**FOR Industrial Rezoning of
56.7ha of land at Hautapu**

STATEMENT OF EVIDENCE (PLANNING)

Plan Change 11 North Access Concept: Review of Proposal

Figure 1 - Option 1 - All external circulatory movements

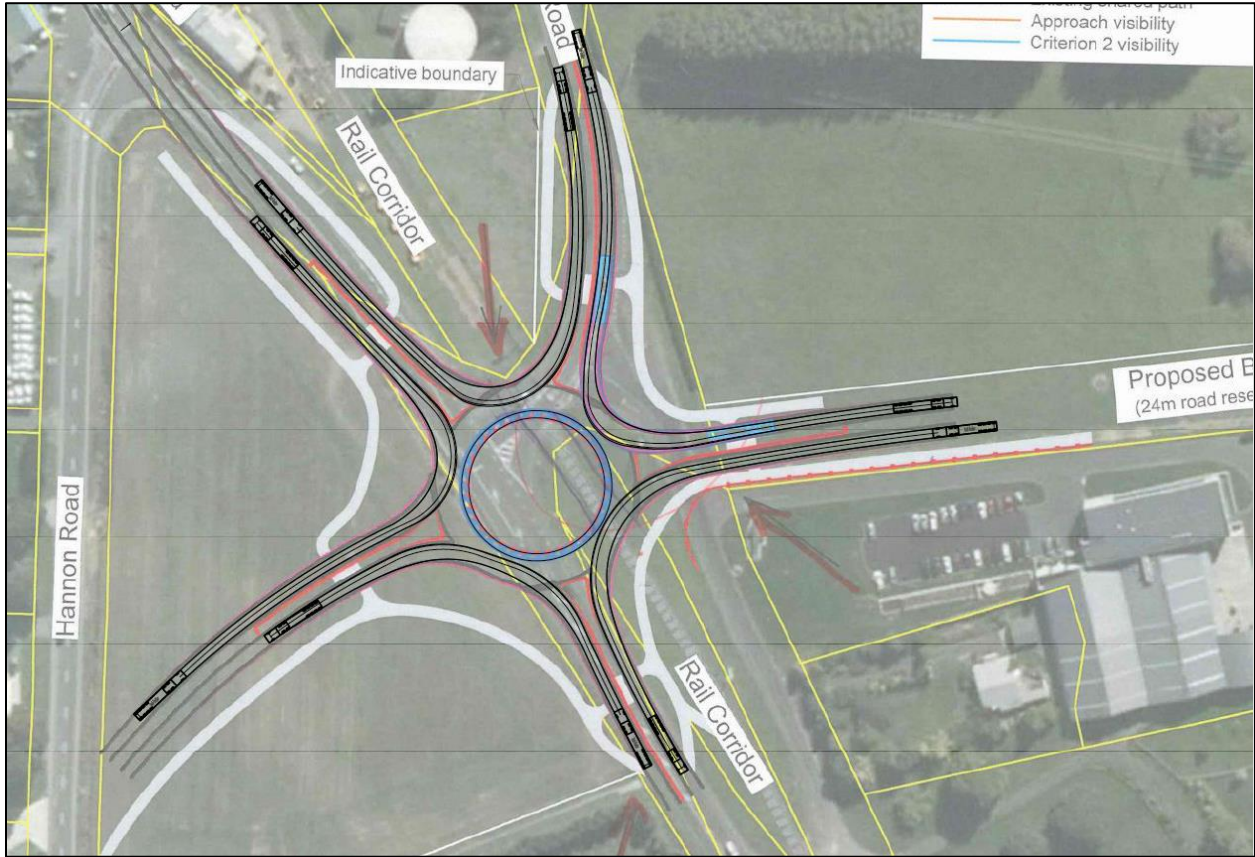
Using the draft design provided as a background, we have reproduced the drawings to scale and confirmed the swept paths for all vehicle manoeuvres for both options. These are reproduced as an appendix to this letter. Using a base design speed of 5 km/h to 15 km/h for the design vehicle, the swept path can be accommodated within the roundabout designs with minor modifications to such things as island width and corner radii. When a higher vehicle speed is used the dynamic forces on the vehicle will cause it to have wider swept paths, and these paths cannot be accommodated within the design. It should be recognised that heavy vehicles will not be able

to travel around the current design roundabouts at the design speeds noted. This does not affect the developer's SIDRA model as this assumes that the speed around the roundabout(s) is reduced from the design speed by the need to slow or stop on the approaches.

Figure 6 - Shoof Industries access turning path

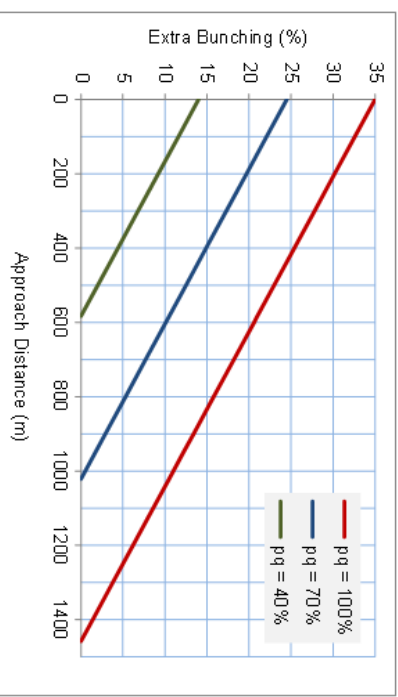
Both proposals show a fence line adjacent to the Shoof International property. This appears to be intended to protect an access route for Shoof International onto Laurent Road. Our assumption is supported by the presence of a vehicle tracking curve to the southern section of the drawings showing the vehicle tracks for the Option 1 five leg roundabout, which indicates that some form of consideration has been given to vehicle tracking from Laurent Road into the southern sector of the development (Stage 1). If this is correct, then the following issues need to be addressed.

- 1 Access issues onto Laurent Road - see Issue 1 above.
- 2 Radius of corner is insufficient for use by large vehicles. This appears to be a 6 to 8 m internal radius as scaled from the available plan. No vehicle tracking information has been provided to confirm that the corner is sufficient to accommodate delivery vehicles to the premises, but our review indicates that an alteration to the verge area in front of the current Shoof sign will be required.

It appears that it would be preferable for Shoof International to have a direct access onto the BIL Road as part of Stage 2 of the development.
